SAF Trailer Air and Mechanical Suspension Axle Systems

Product Change Notice for SAF Trailer Drum Brake Axle Camshaft Bearings

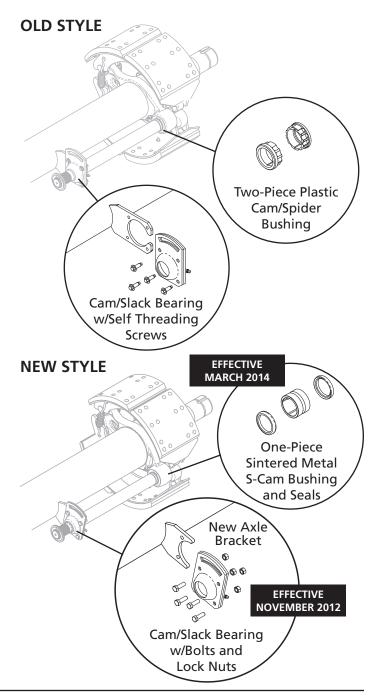
The cam/slack bearing assembly fastens to a new welded axle bracket with (4) four bolts and lock nuts in place of (4) self-threading bolts (OLD STYLE). These component changes will not change fit, form or function.

The cam/spider bushing has changed from a twopiece plastic bushing design (OLD STYLE) to a one-piece sintered metal bushing design with seals (NEW STYLE). These component changes will not change form or function.
